# TECHNICAL BULLETIN

## Poor Idle Quality – Normally Aspirated AJ16 Engine – Valve Timing Modification

12-57

MODEL 4.0L Normally Aspirated 1995 MY DATE 8/95

ILLUSTRATION 1

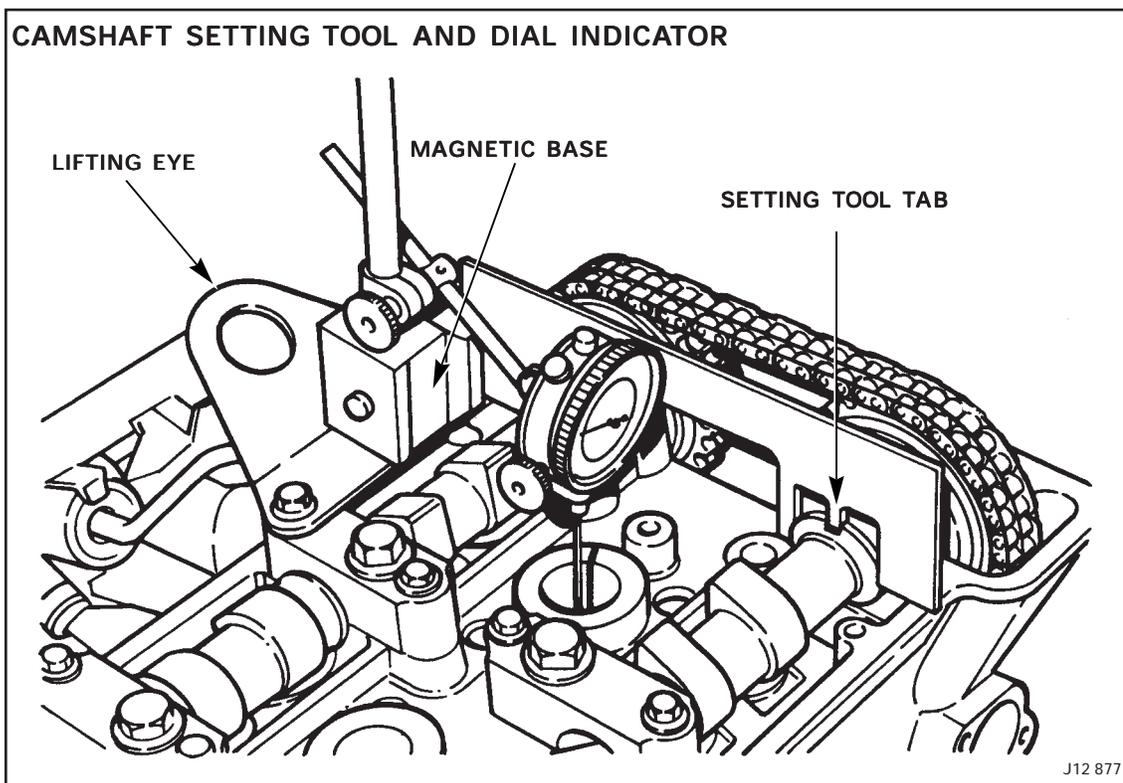
The original camshafts, with a maximum opening position of 110 degrees have been superseded by camshafts with a maximum opening position of 114 degrees. This change is accomplished by machining the camshaft slot in a different

position. The valve timing overlap is reduced from 22 degrees on the 110 camshafts to 14 degrees on the 114 camshafts, Illustration 1.

5. Turn the crankshaft until the No. 1 cylinder is at Top Dead Center (TDC) on the compression stroke, i.e. with the cam lobes on the No. 1 cylinder pointing upwards as in Illustration 1. This position can be checked by temporarily inserting the camshaft setting tool 18G-1433/A into the slot on each camshaft.

7. On all engines, attach an engine lifting eye to the intake camshaft cap as shown in Illustration 1.
8. Position the magnetic base of a dial indicator gauge on the lifting eye.

ILLUSTRATION 2

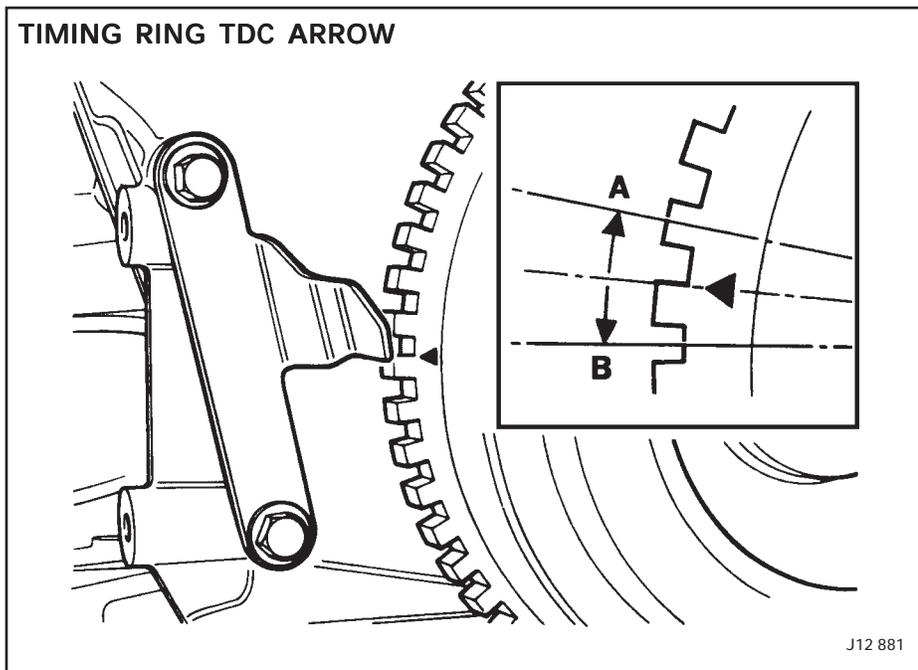
12. Check that the pointer on the front timing cover is in line with the arrowed (TDC) tooth edge on the timing ring, Illustration 2. Realign the pointer if necessary.
13. The crankshaft positions for resetting the camshafts are one and a half teeth on either side of the arrowed (TDC) tooth edge on the timing ring as shown in Illustration 2.
14. Rotate the crankshaft two revolutions in a clockwise direction (viewed from the front of the engine) until the pointer is one and a half teeth before the arrowed (TDC) tooth edge on the timing ring, position A, Illustration 2.

19. Install the locking tabs and the coupling bolts. Lightly tighten the bolts.
20. Remove the setting tool and turn the crankshaft in a clockwise direction (viewed from the front of the engine) until the pointer is one and a half teeth after the arrowed (TDC) tooth edge on the timing ring, position B, Illustration 2.

27. Check both the settings of one and a half teeth before and after the arrowed (TDC) tooth edge on the timing ring, Illustration 2. The tab of the setting gauge should fit in the slot of the camshaft being checked.

ILLUSTRATION 3

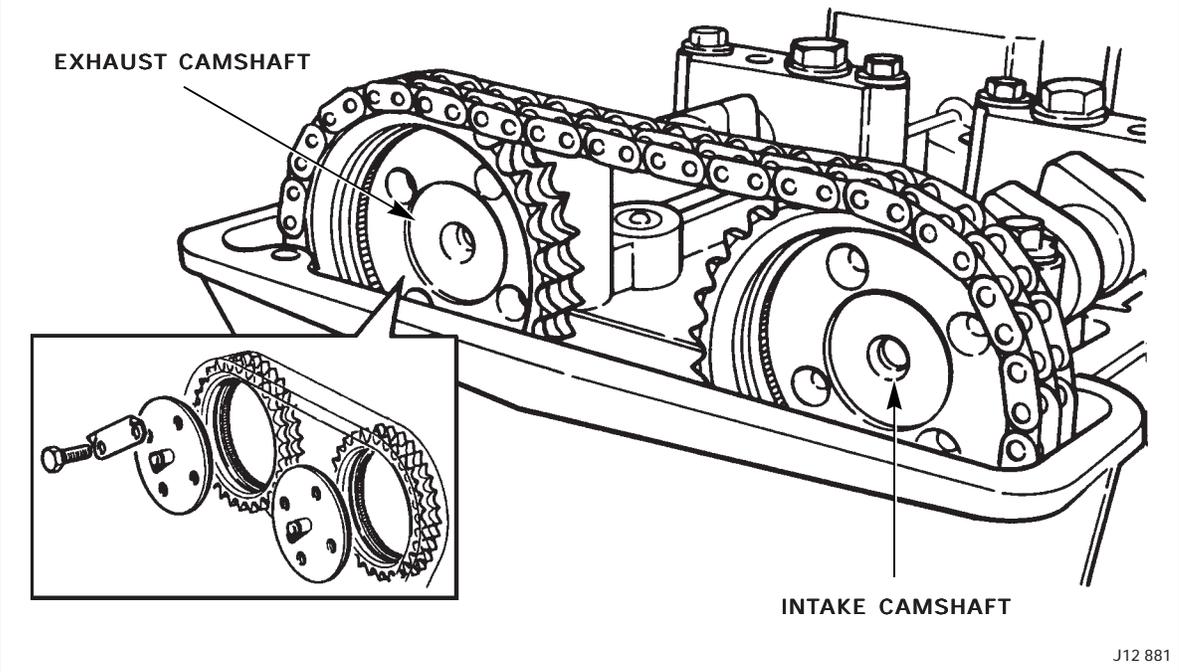
15. Remove the retaining bolts and the camshaft sprocket vernier coupling, Illustration 3, from the exhaust camshaft, but do not detach the sprocket from the camshaft flange. The camshaft is free to rotate inside the sprocket with the coupling removed.
16. Position the camshaft setting tool 18G-1433/A across the camshafts with the positioning tab on the exhaust camshaft, Illustration 1.
17. Turn the exhaust camshaft until the tab on the setting tool engages the slot in the camshaft.
18. With the camshaft in this position, reinstall the sprocket vernier coupling to the exhaust camshaft. This step will require several attempts to find the exact alignment of the vernier splines and the bolt holes.

21. Remove the retaining bolts and the camshaft sprocket vernier coupling, Illustration 3, from the intake camshaft, but do not detach the sprocket from the camshaft flange. The camshaft is free to rotate inside the sprocket with the coupling removed.
22. Position the camshaft setting tool 18G-1433/A across the camshafts with the positioning tab on the intake camshaft.
23. Turn the intake camshaft until the tab on the setting tool engages the slot in the camshaft.
24. With the camshaft in this position, reinstall the sprocket vernier coupling to the intake camshaft. This step will require several attempts to find the exact alignment of the vernier splines and the bolt holes.
25. Install the locking tabs and the coupling bolts. Lightly tighten the bolts.

ILLUSTRATION 4

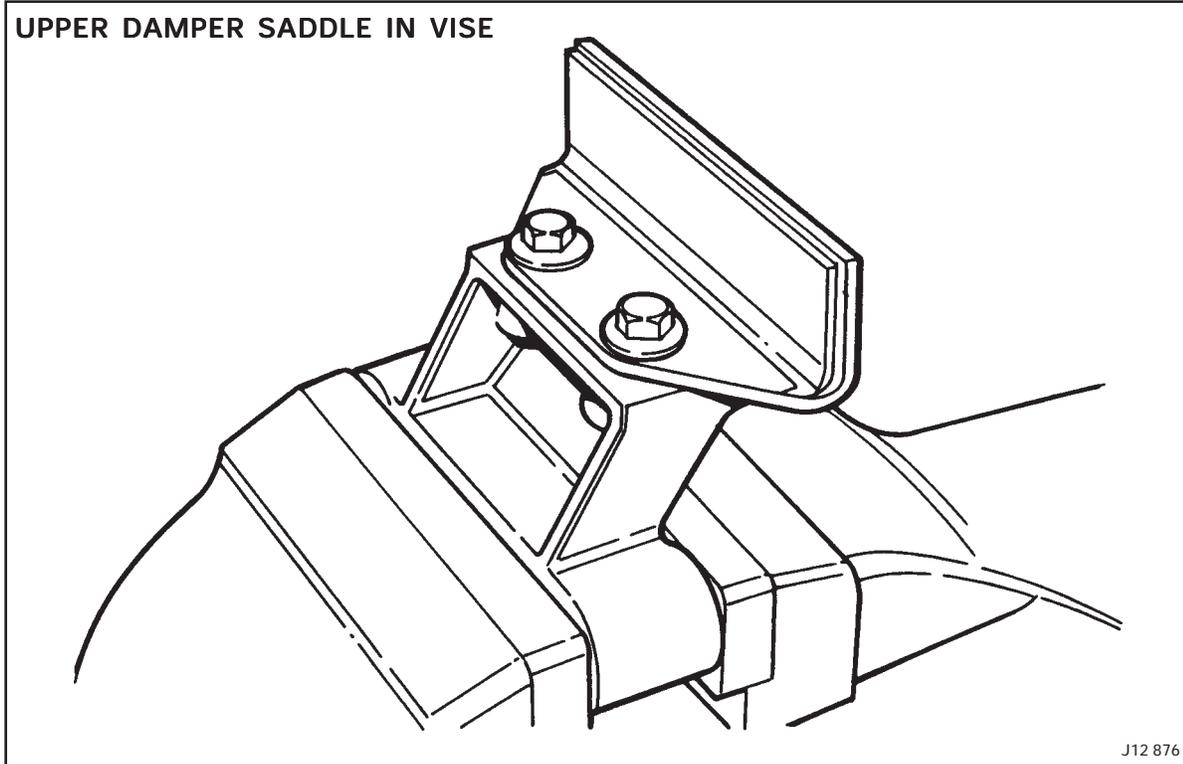
28. Remove the setting tool, the dial indicator gauge, and the lifting eye. Torque camshaft bearing cap bolt to 12.5 - 16.9 lb ft (17 - 23 Nm).
29. On engines with numbers below 9L103934 (XJS Range) or 9J103935 (Sedan Range) only, remove the damper saddle retaining bolts, Illustration 4. Thoroughly degrease the bolts and the saddle. Apply Loctite 545, part number 54531 to the bolt threads and torque to 15.8 - 21 lb ft (21.5 - 28.5 Nm). Install the damper saddle using new cylinder head bolts and torque to 43.5 - 44.9 lb ft (59 - 61 Nm) plus 90 degrees as described in section 2.1 of the AJ16 Engine Service Manual.

ILLUSTRATION 5

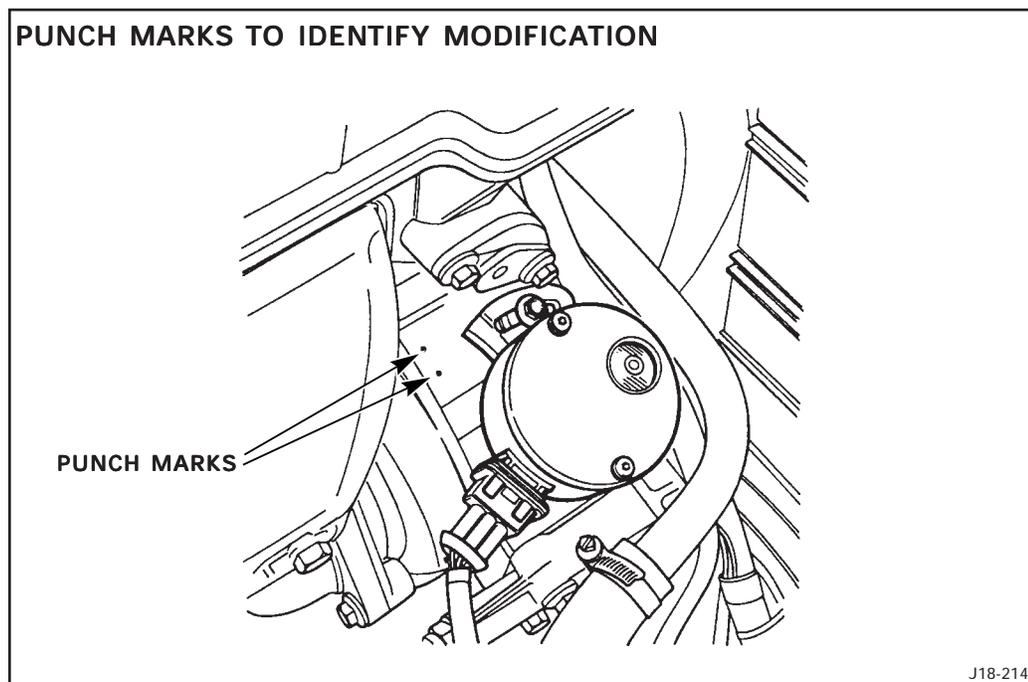
In case of a customer complaint of poor idle quality on a vehicle equipped with the 110 camshafts only, first check for punch marks on the timing cover near the camshaft position sensor, Illustration 5, to determine if the timing modification has already been performed. If not, reset the camshaft timing and spark plug gap as described below.

33. Place two punch marks approximately 1/4 inch apart on the timing cover parallel to the lip, Illustration 5, to indicate that the modification was done.
34. Connect the battery negative cable and reset the clock.
